STATEMENT OF JUSTIFICATION
DSP-21019

Re: Arcland Self Storage
Detailed Site Plan, DSP-21019

WSSC Plan Review Comments
DSP-21019 - ArcLand Self Storage

ARCLAND SELF STORAGE

DSP-4

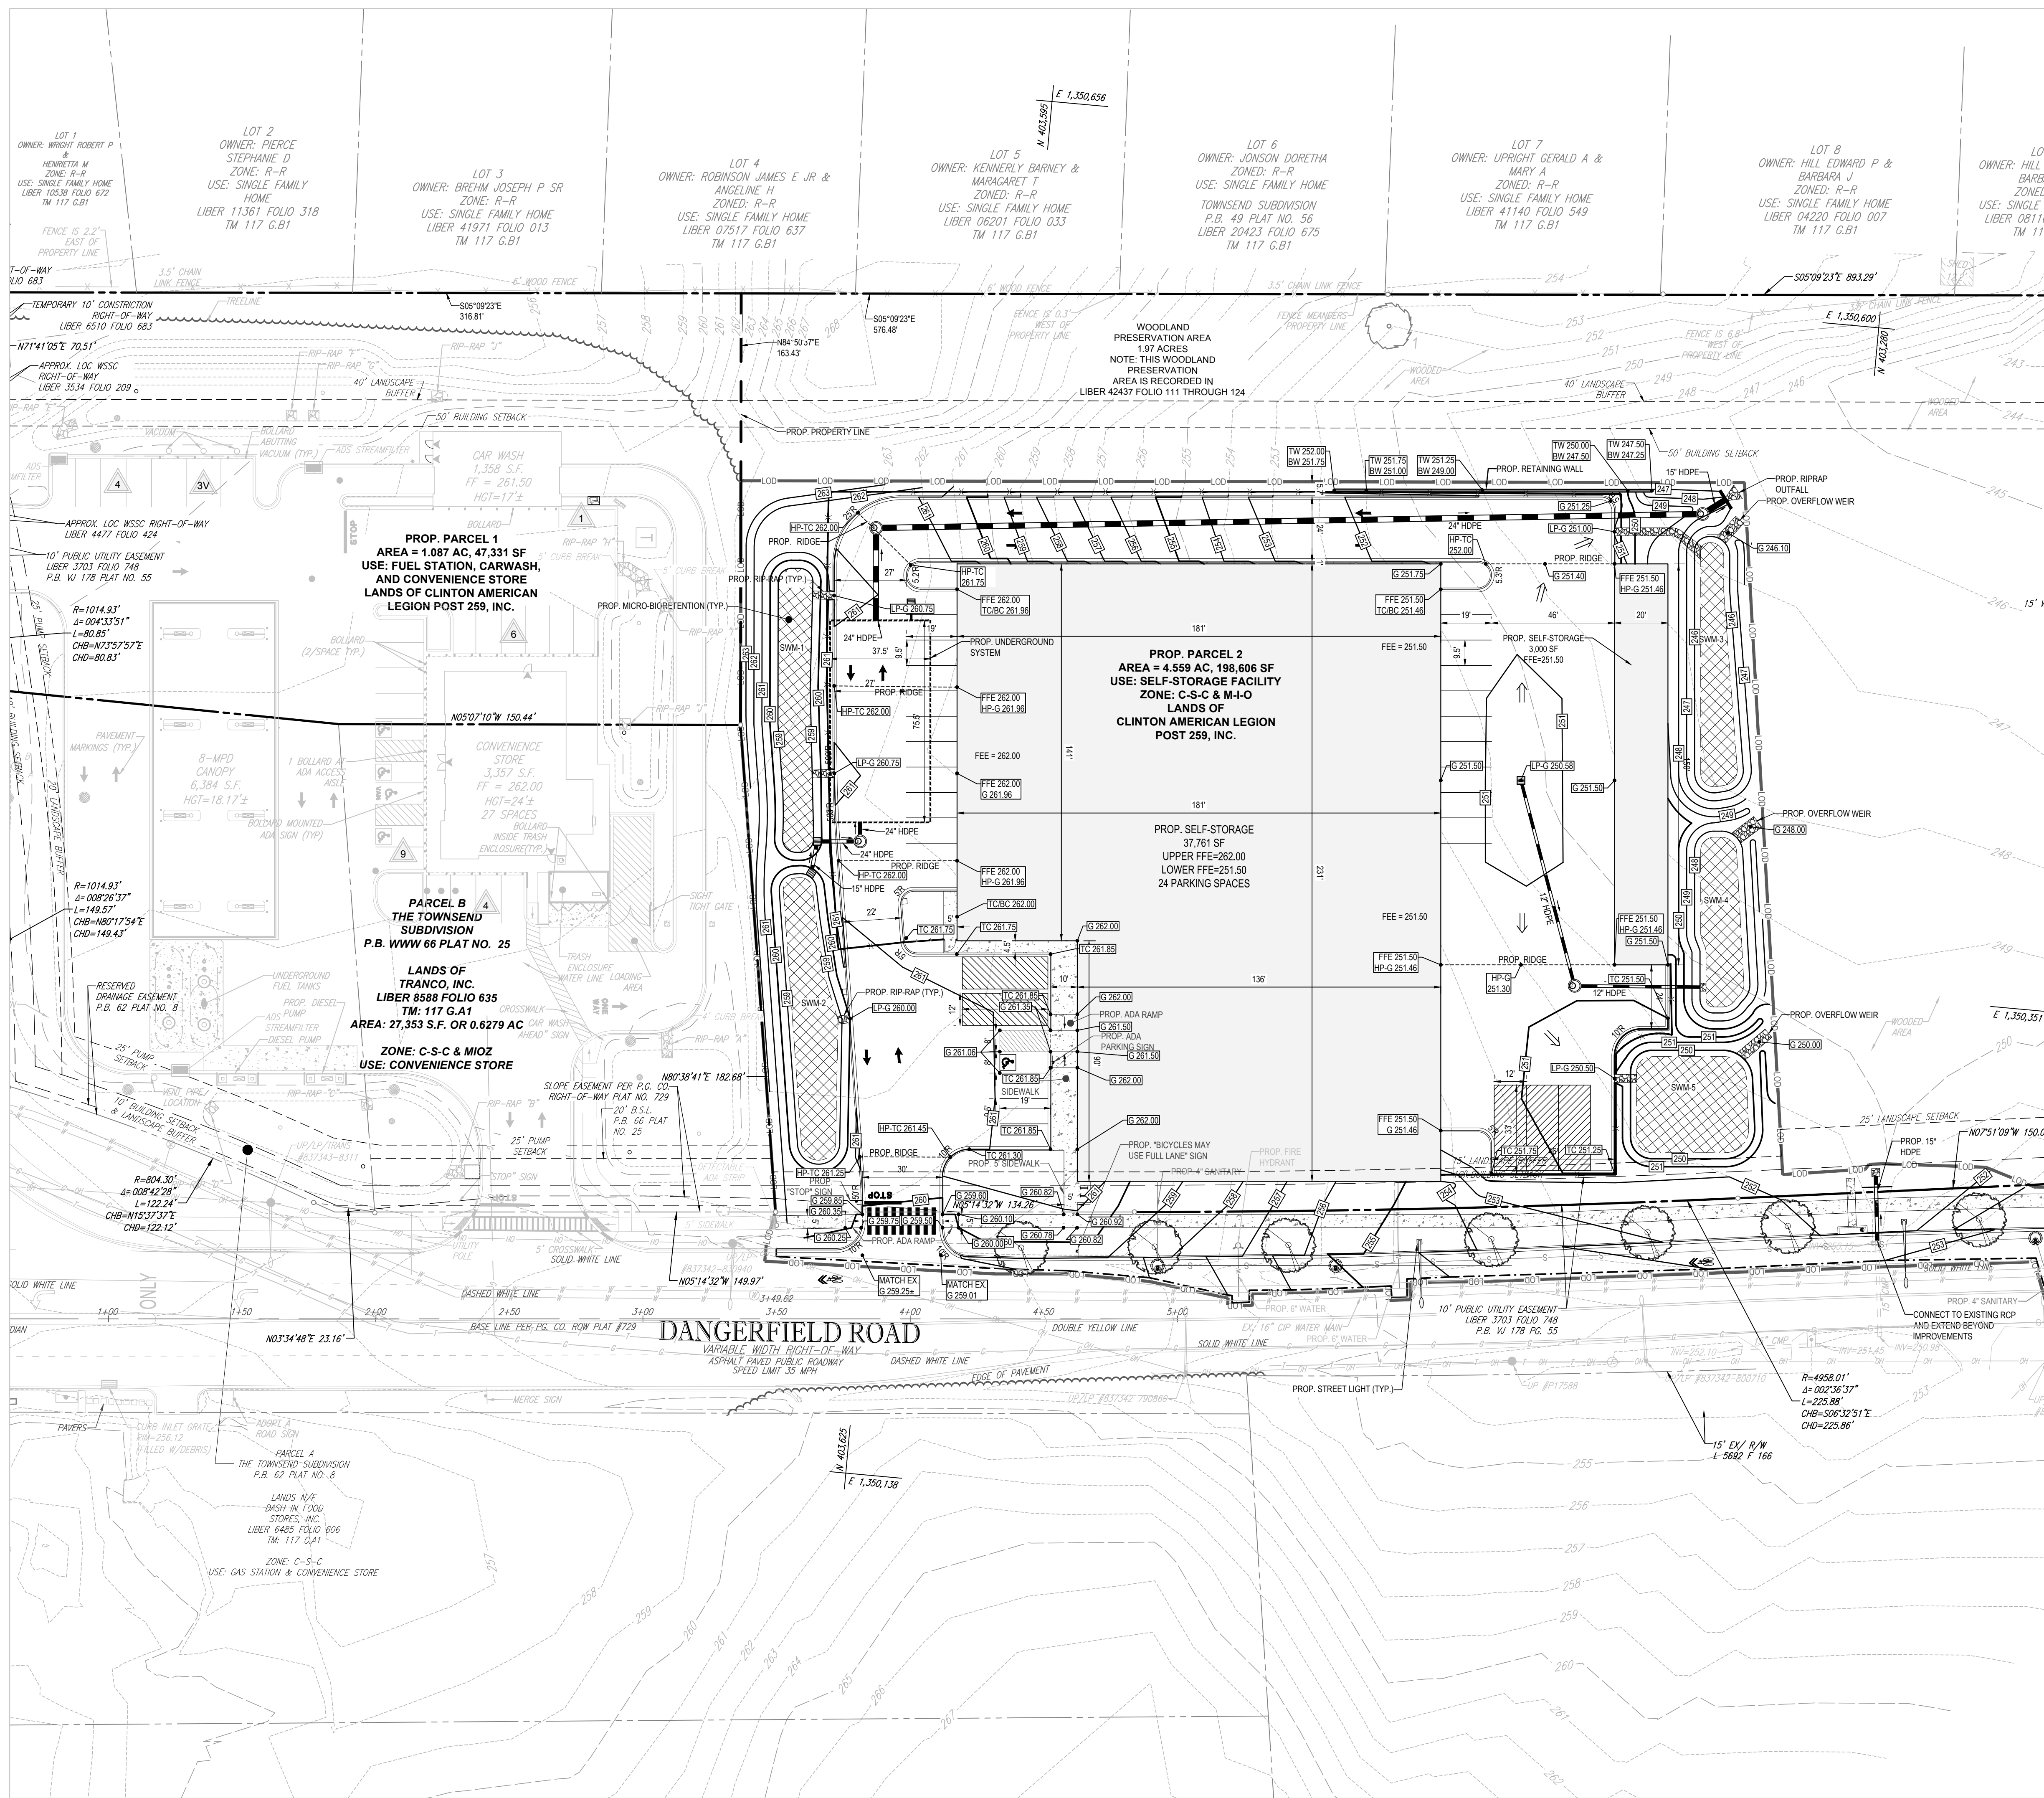
- Sheet DSP-4 in Detailed Site Plan set shows the driveway entrance with a 10' radius. County standard for a commercial driveway entrance is a minimum radius of 12' per DPW&T Specifications and Standards. The applicant will provide driveway entrance that meets County standards.

Response: Please refer to sheet 4 where the site plan demonstrates conformance with the loading space requirements.

Response: Please refer to sheet 4 where the site plan has been updated to accommodate a width of 22 feet for two-way vehicular travel.

to omit the reference to the car wash and convenience store. Please refer to sheet 4 of the detailed site plan where the crosswalk traversing the drive aisle at the entrance has been updated as a continental-style crosswalk.
